**STAFF REPORT**  
**KETCHUM PLANNING AND ZONING COMMISSION**  
**June 14, 2022 MEETING**

**PROJECT:** McDermott Residence Mountain Overlay Design Review

**FILE NUMBER:** P22-002

**REQUEST:** Mountain Overlay Design Review

**GRADING & DRAINAGE PLAN**  
KETCHUM TOWNSITE BL 91, LOT 1A  
T4N, R18E, SEC 18, B.M., KETCHUM, IDAHO  
PREPARED FOR: CLB ARCHITECTS

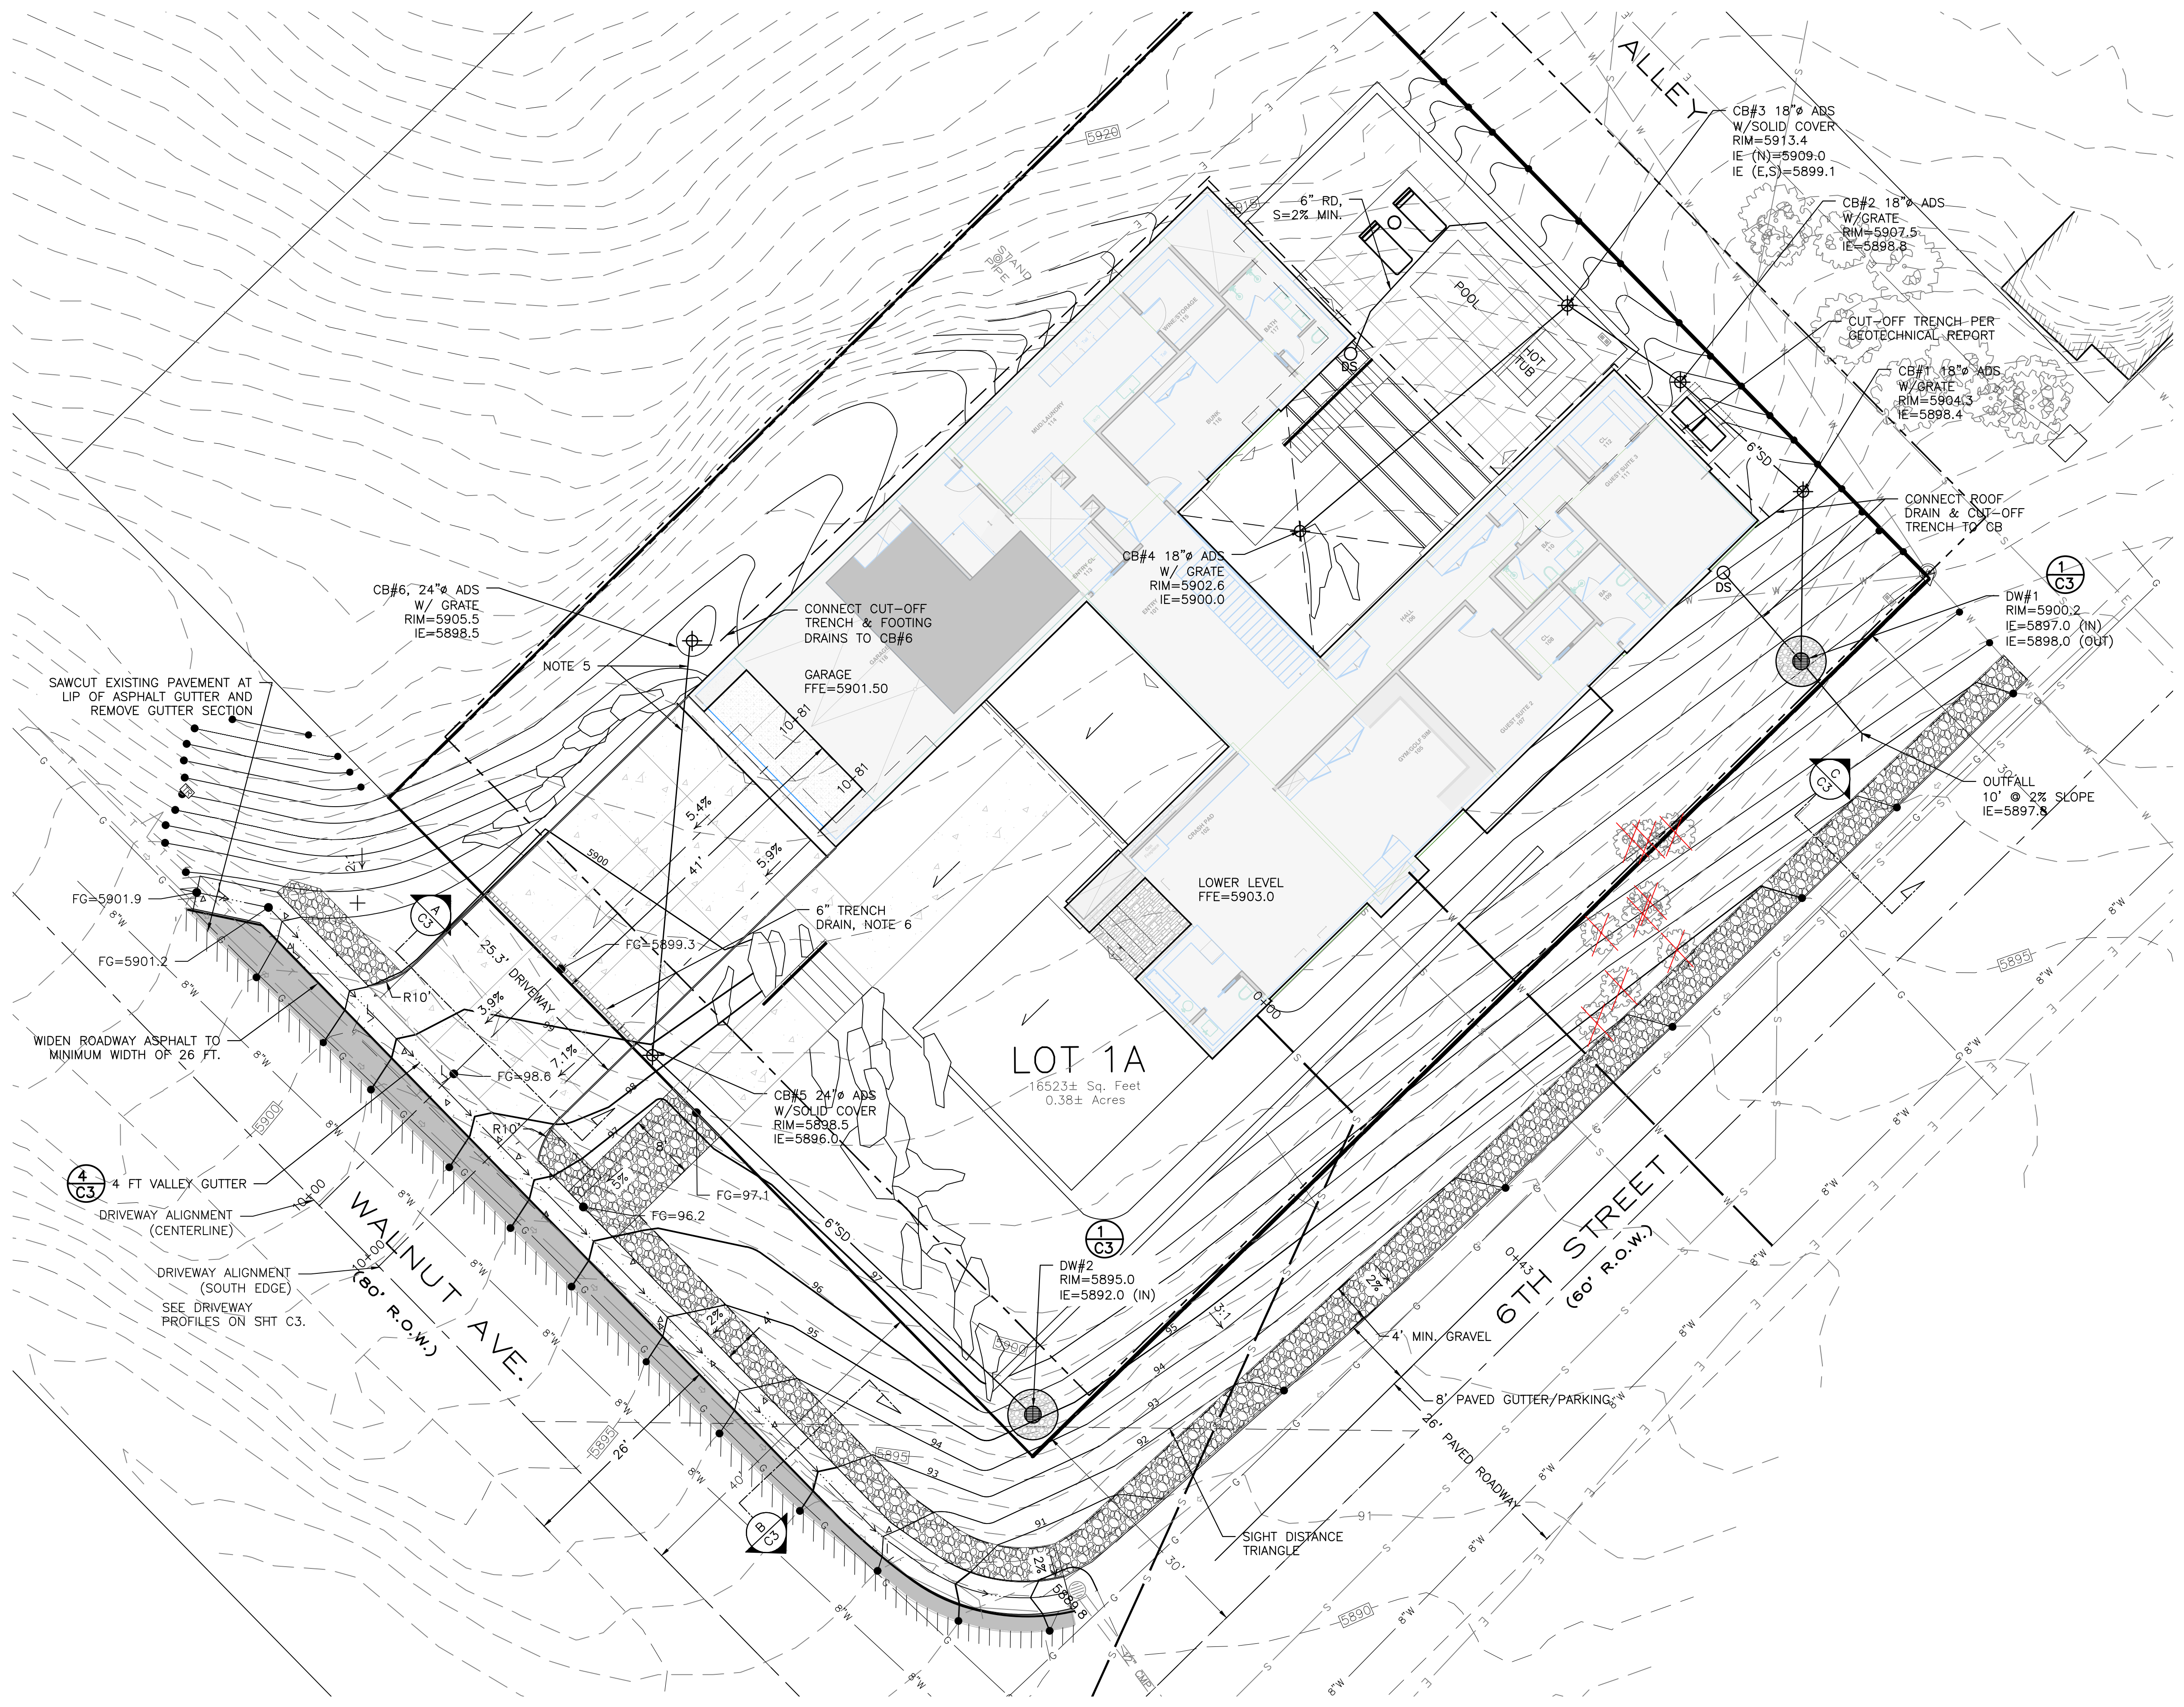
<i>Staff Comments</i>	<i>The applicant proposes to retain all stormwater on site. See sheet C1. The drainage and grading plan will be reviewed and approved by the City Engineer and Streets Department Director through the Building Permit review and approval process.</i>
<input checked="" type="checkbox"/>	<input type="checkbox"/>	<input type="checkbox"/>	17.96.060(C)(2)	<b>Drainage improvements constructed shall be equal to the length of the subject property lines adjacent to any public street or private street.</b>
			<i>Staff Comments</i>	<i>See sheet C1. Drainage improvements constructed along Walnut Ave &amp; 6<sup>th</sup> St property lines.</i>

DRAWING NO.  
**C2**

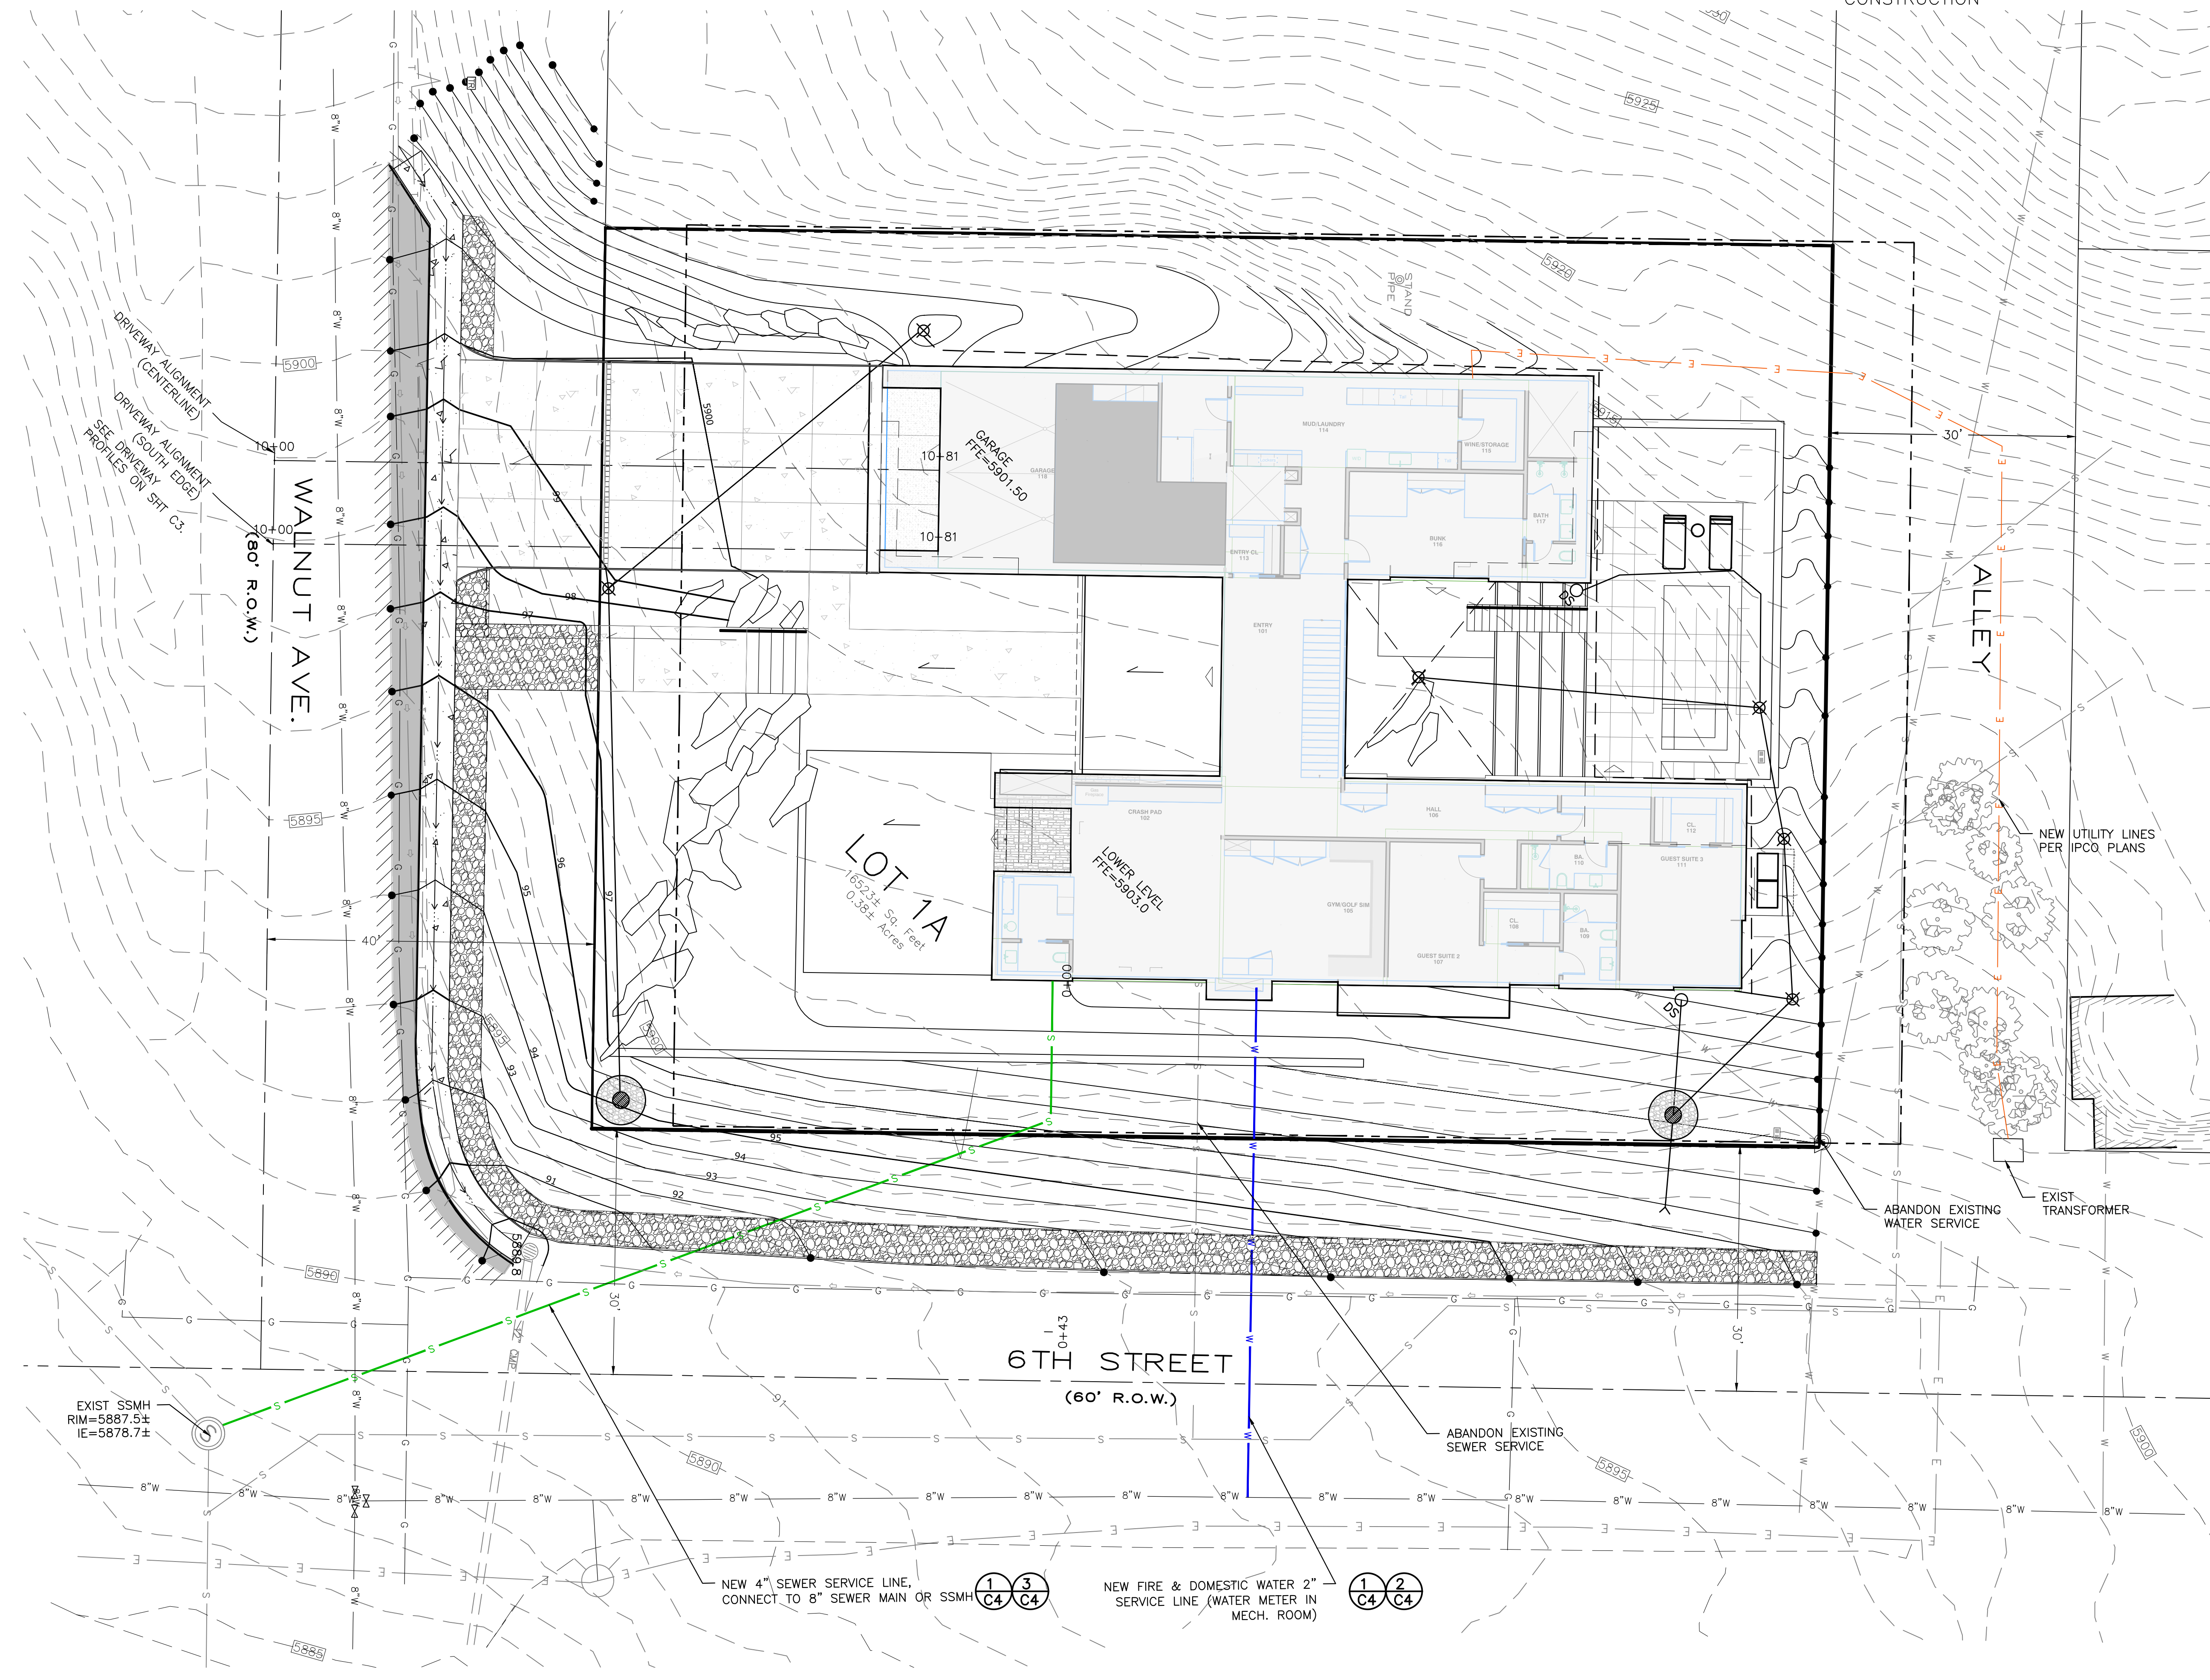
<i>Staff Comment</i>	<i>As indicated on Sheet C2 of the submittal, the applicant has proposed a system of drywells to control drainage on the site. Pursuant to KMC 17.96.060.C.1, all storm water drainage shall be retained on site. All drainage plans and specifications shall be reviewed and approved by the City Engineer and Streets Department prior to issuance of a Building Permit for the project.</i>
<input checked="" type="checkbox"/>	<input type="checkbox"/>	<input type="checkbox"/>	17.104.070 A (9)	<b>Cuts and fills allowed for roadways shall be minimized; lengths of driveways allowed shall be minimized; all cuts and fills shall be concealed with landscaping, revegetation and/or natural stone materials. Revegetation on hillsides with a clear zone of thirty feet (30') around all structures is recommended. Said clear zone shall include low combustibile irrigated vegetation with appropriate species, on file with the Ketchum planning department. Revegetation outside of this clear zone should be harmonious with the surrounding hillsides.</b>
